Subject: Section 3.7 & 3.8 Actions - Updated December 1, 2011

Punch List for South Texas Project Units 3 & 4
Sections 3.7 & 3.8

**South Texas Project Units 3 & 4
Clarifications from NRC**

Issue 8: [Received 04/04/2011] (Audit Action Item 3.7-33 and 35) Stability Analysis Procedure

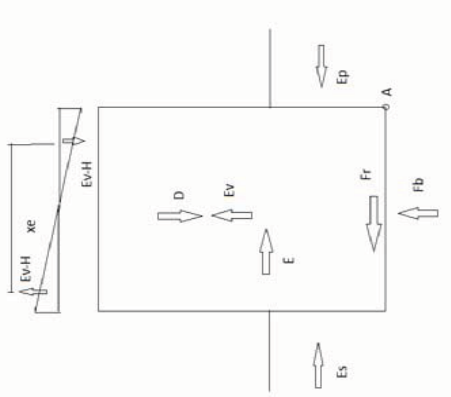
A brief presentation of the stability analysis procedure was made by the applicant during the March 14, 2011 audit. The presentation included a rigid body diagram showing the forces acting on the structure for stability calculations. The applicant indicated that the total seismic demand is calculated by summing all the inertia forces and moments acting on the structure. These inertia forces are calculated by multiplying the mass of each node by the absolute value of the maximum acceleration response at that node obtained from the SSI analysis.

The calculation of the seismic overturning moment is based on the horizontal seismic load E and vertical seismic load E_v about tipping point A , as shown in the figure below. The moment due to horizontal earthquake does not include E_v-H (vertical force due to horizontal input) which also produces overturning moment about A . The applicant is requested to provide justification for not including the vertical component of response due to horizontal seismic input in calculating the foundation overturning moment.
